ADDENDUM #2

Rye City School District

Osborn Elementary School

Midland Elementary School

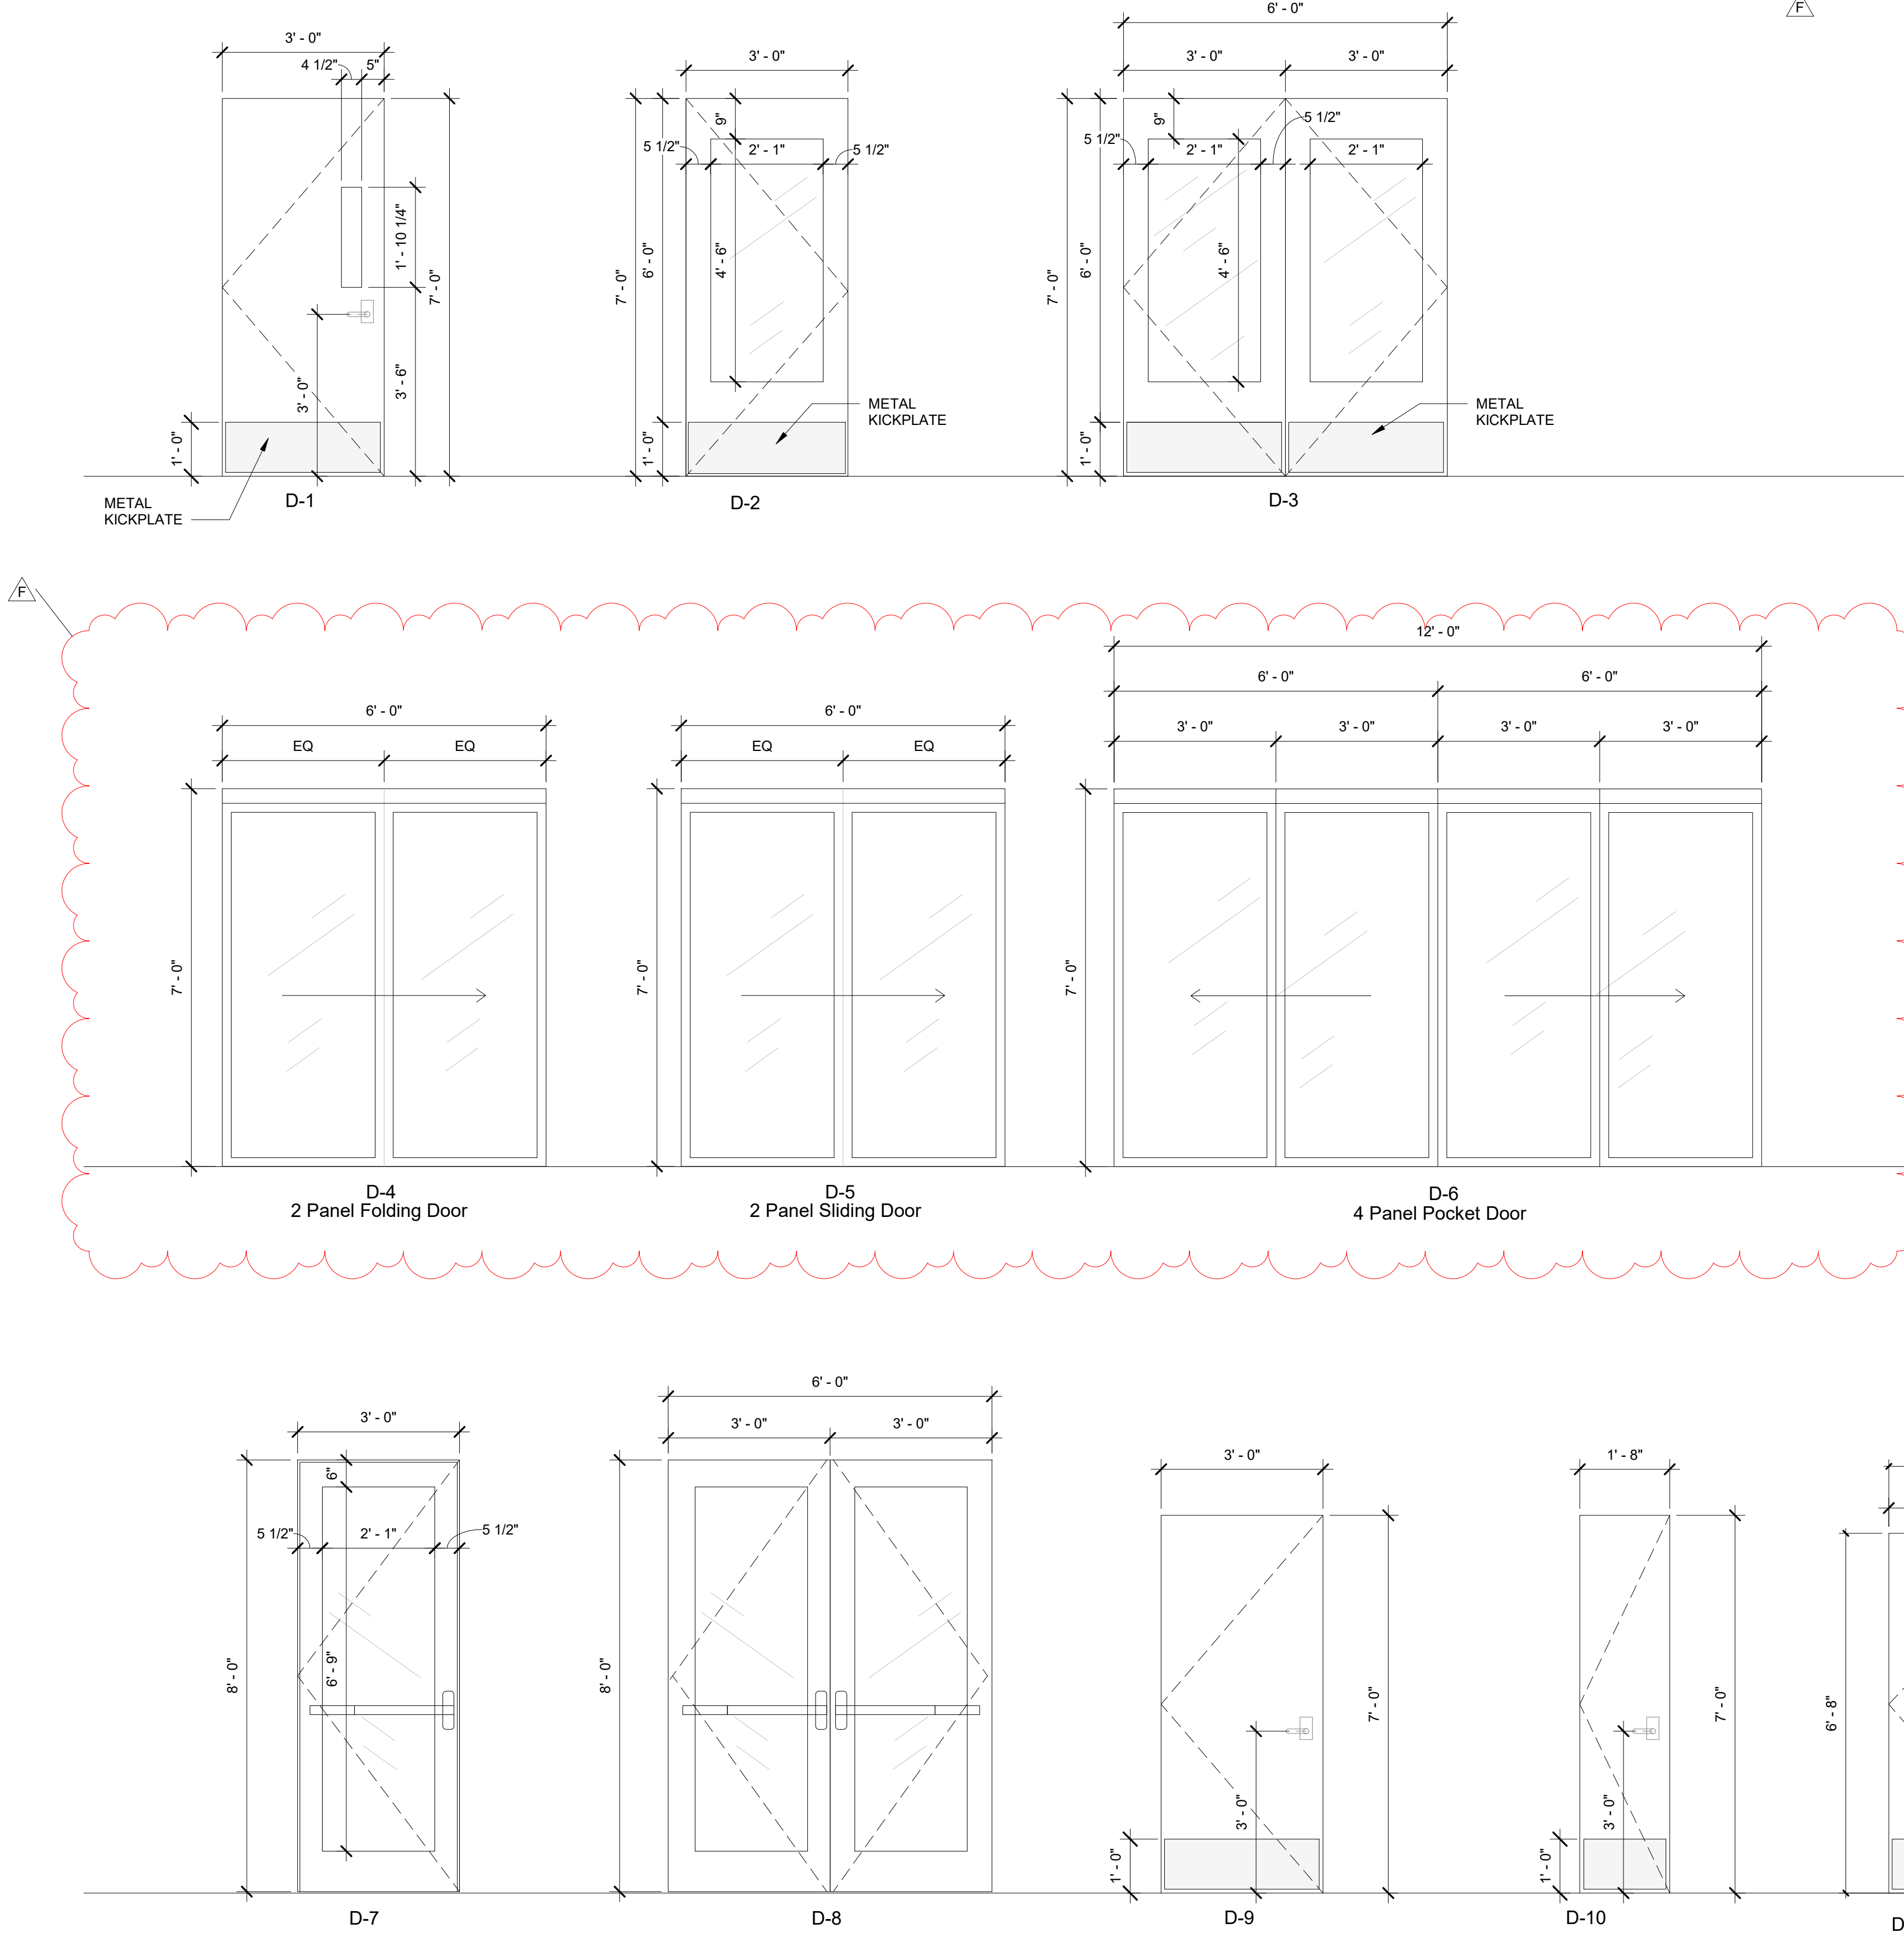
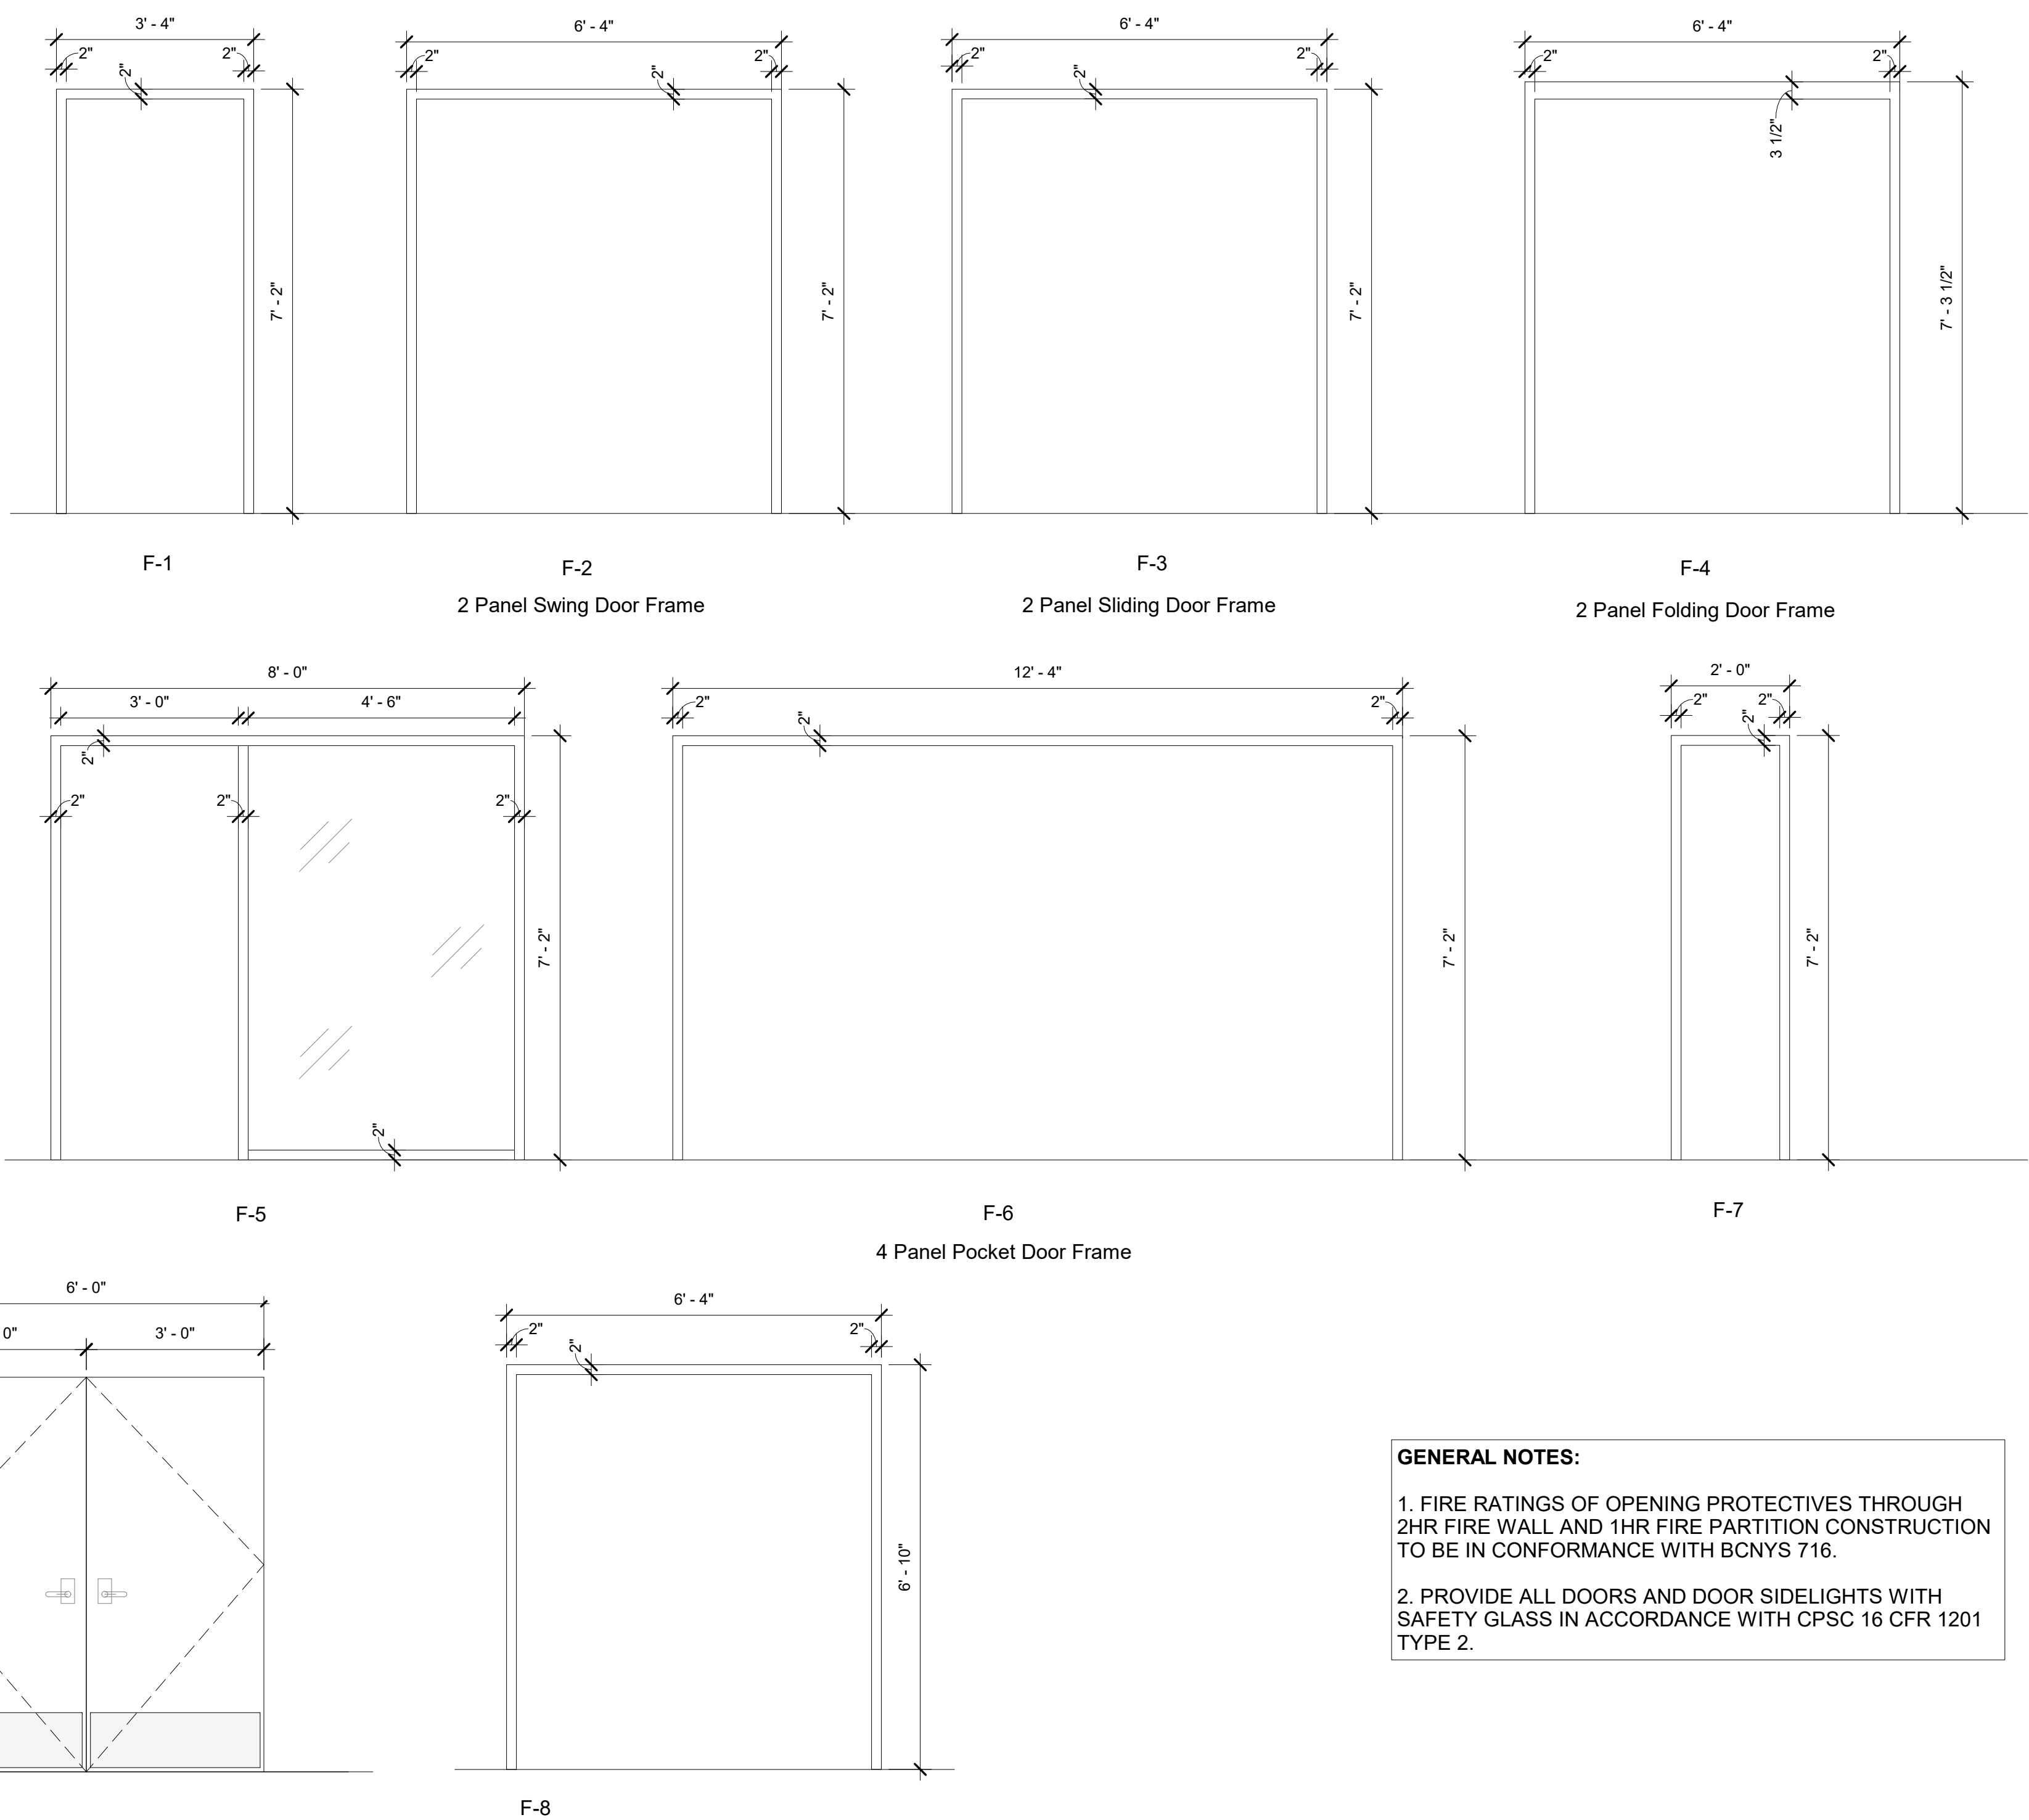
- a. "Detail" Column added to door schedule
- b. Door Types D4, D5, and D6 updated to show aluminum frames and pocket doors.
